**REVISION 002 TO A
INVITATION TO TENDER**

Title - Sujet : Lake Louise Waste Water Treatment Plant Rehabilitation – Banff National Park	
Solicitation No. - N° de l'invitation : 5P420-20-0448/A	Date : April 6, 2021
Amendment No. - N° de modification : 002	
Client Reference No. - N° de référence du client : 1480	
GETS Reference No. N° de référence de SEAG : PW-21-00949500	
Solicitation Closes - L'invitation prend fin : At - à : 2:00 PM On - le : April 15, 2021	Time Zone - Fuseau horaire MDT - HAR
F.O.B. - F.A.B. : Plant - Usine : <input type="checkbox"/> Destination : <input checked="" type="checkbox"/> Other - Autre : <input type="checkbox"/>	
Address Enquiries to - Adresser toutes demande de renseignements à : Rebecca Chen	
Telephone No. - N° de telephone : (587) 439-3529	Fax No. -N° de télécopieur : (866) 246-6893
Email Address – Courriel : rebecca.chen2@canada.ca	
Destination of Goods, Services, and Construction - Destination des biens, services, et construction : See Herein – Voir ici

Amendment 002

This amendment is being raised to distribute the mandatory site visit information, questions and answers and to make changes to the tender package.

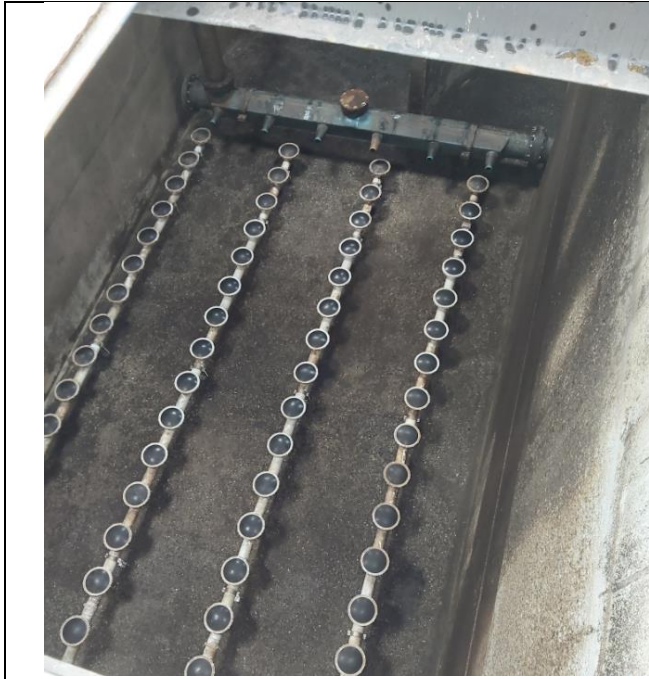
Q7. Provide and install process air flow control valves (FCV-11, 12, 13, 21, 22, 23) as per specified DV1- Diaphragm valves in Section 40 92 13.01, 75 mm diameter.

A7. Add NOTE 7 to drawing 2.P2-01: 7. REMOVE EX 150-FR-MS INSIDE BUILDING. FILL THE RESIDUAL PIPE (WALL PENETRATION) WITH NON-SHRINK GROUT.

Bioreactor Photo 6

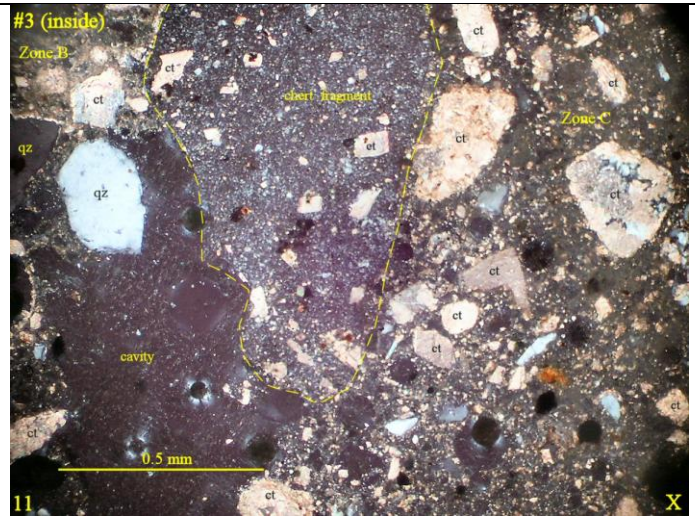
Q9. Include photos of the inspection of the empty bioreactor and concrete core analysis.

A9.
